**Final PRE-APPLICATION CONFERENCE**  
**Lockwood Meadows Subdivision Lots 13,14,16,24,26,27,31,34,35, & 64**  
**Attached ADU's**  
**2024-013 PAC**

Date Issues	July 3, 2024

# Site Plan

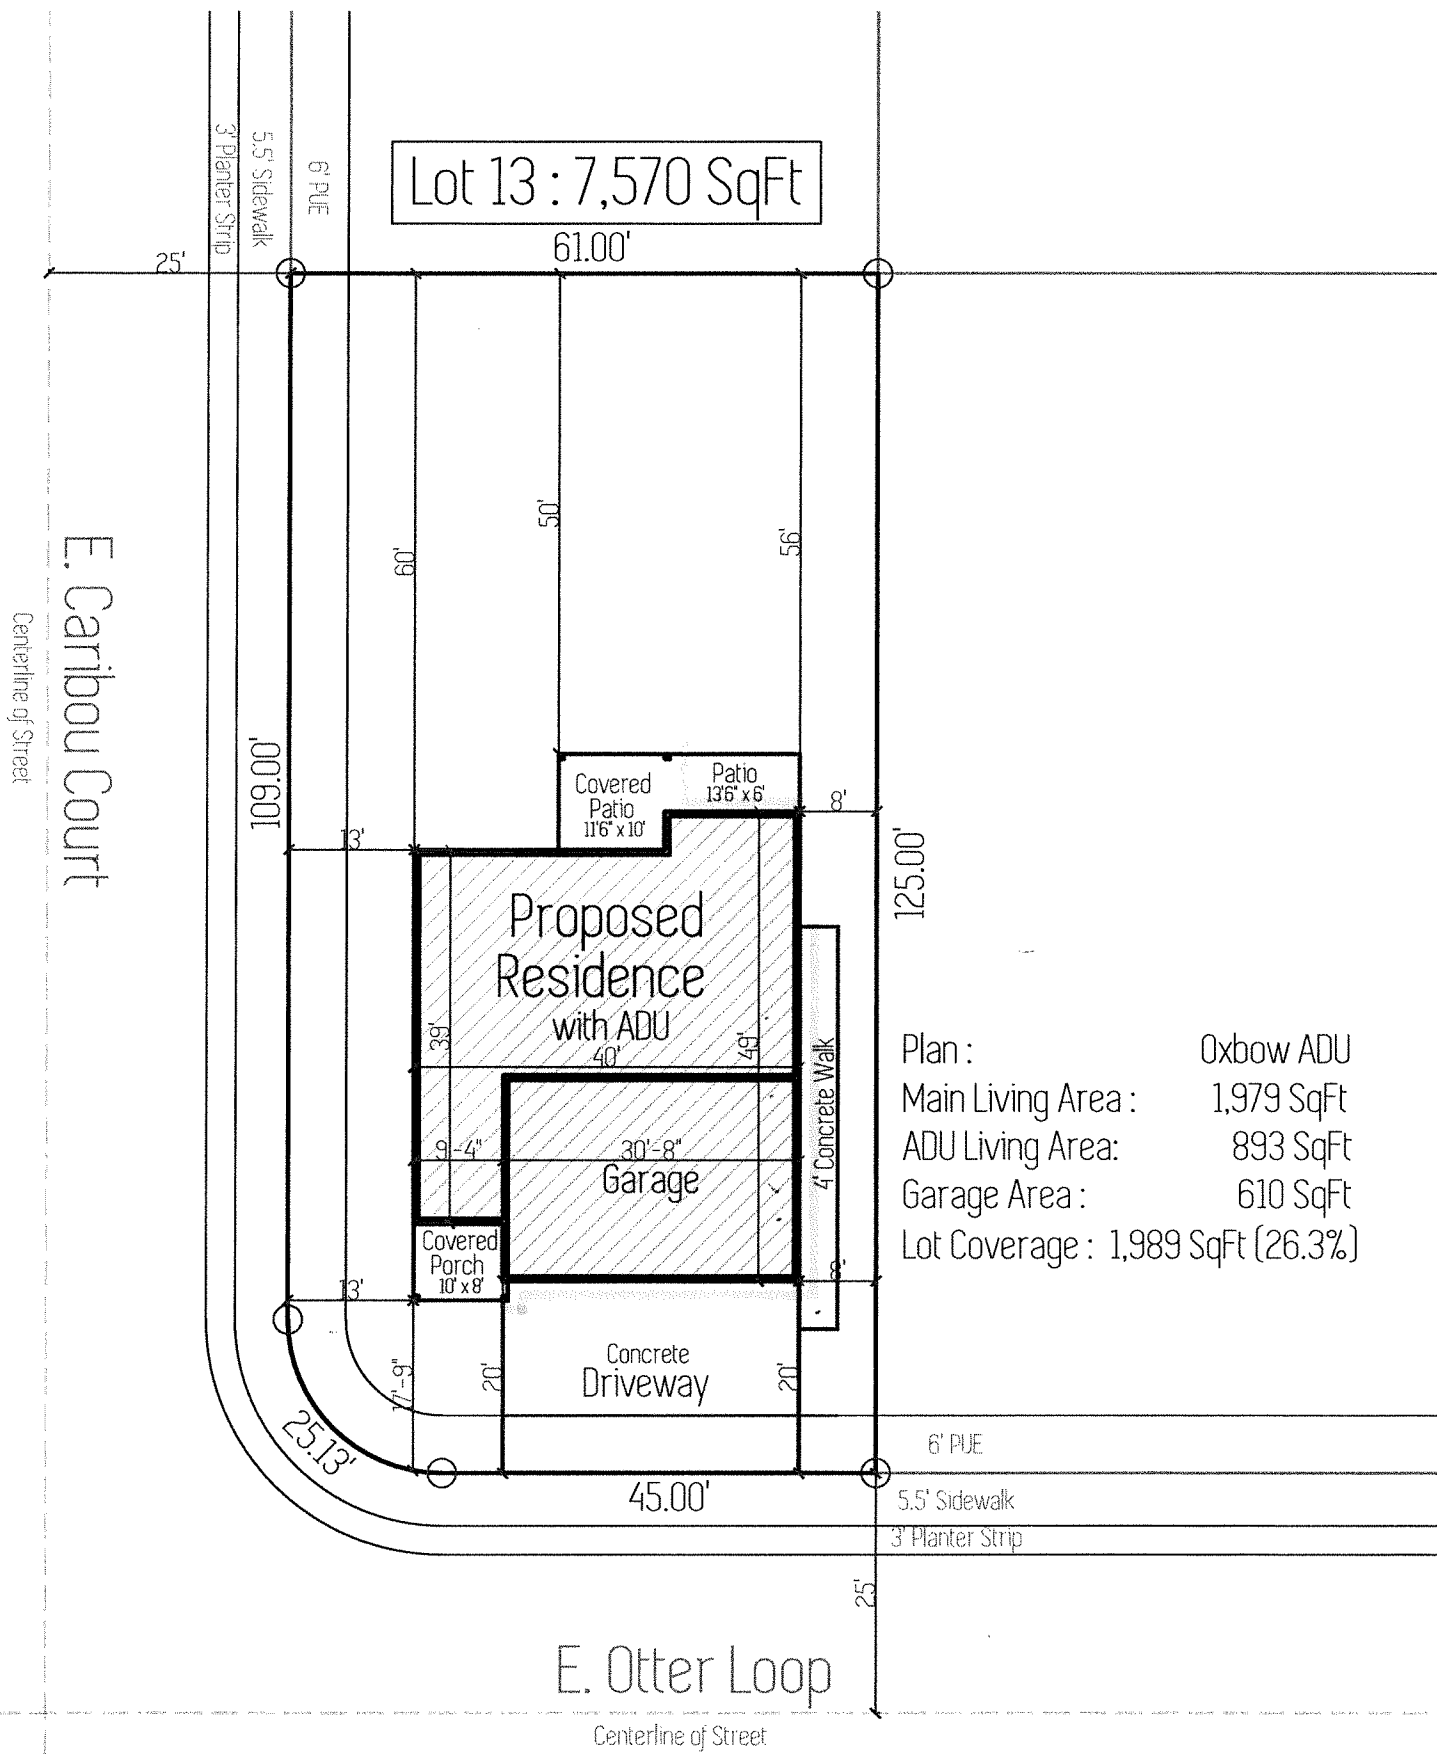
- e. ADU's shall adhere to the front setbacks of the underlying zone and shall not be closer to the front lot line than the single-family dwelling. *[The drawings provided for the proposed ADU's show the ADU's will adhere to the 20-foot front yard setbacks]*

- f. Consistent with Table 18.130.080, Footnote 3, ADU's require a setback of 10 feet from street side lot lines, five feet from interior side and rear yard lot lines, and six feet from the single-family dwellings. *[All proposed ADU's shall meet the ADU setback requirements]*

- i. One off-street parking space is required for ADUs in addition to the parking required for the single-family dwelling. The parking requirement can be met by existing parking on site. If insufficient off-street parking exists on site to meet the single-family requirement plus the one additional space for the ADU, then additional off-street parking shall be provided. *[The proposed single-family homes have a three (3) car garage with a 30' driveway. [The proposed ADU's will meet the on-site parking]*

- k. Additional access may be provided to an ADU if it meets city driveway standards. *[The proposed plans show an access for the ADU's located on the interior side yard of the residence]*

# Elevations

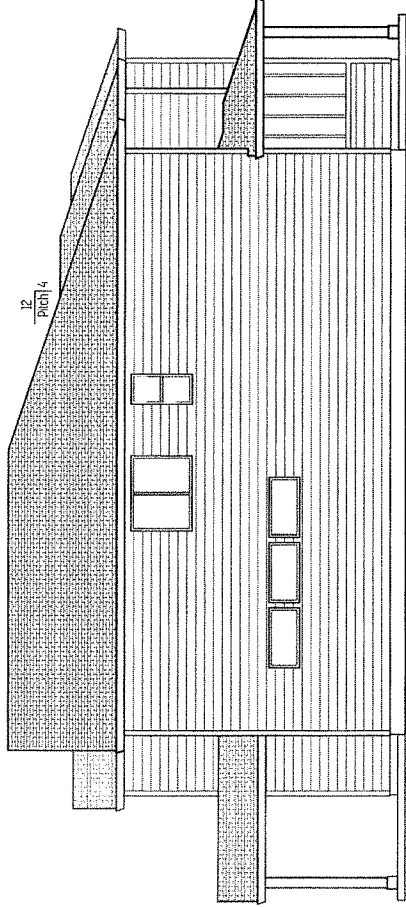
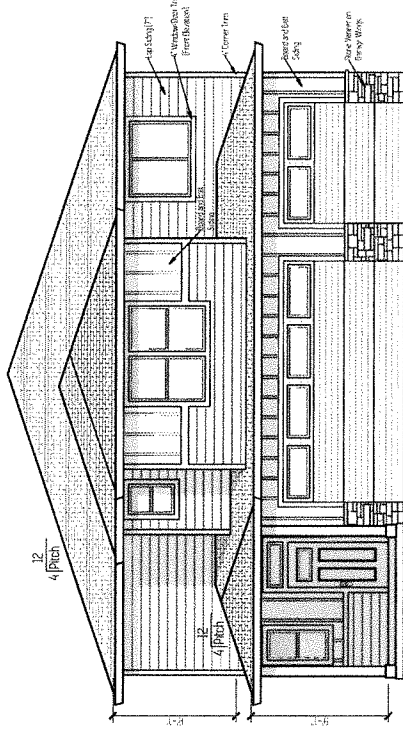
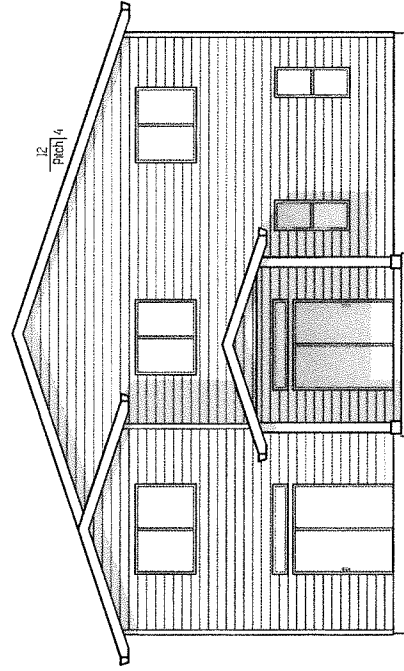
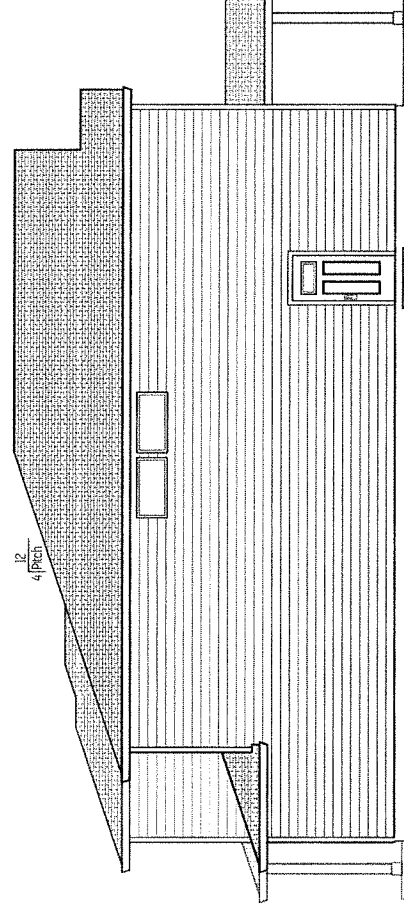
- h. The exterior appearance of an addition or detached ADU shall match the single-family dwelling's siding, color, and roof form and pitch. *[The plans submitted show the proposed ADU's to match the proposed single-family residence. All proposed ADU's shall match the appearance of the single-family residence]*
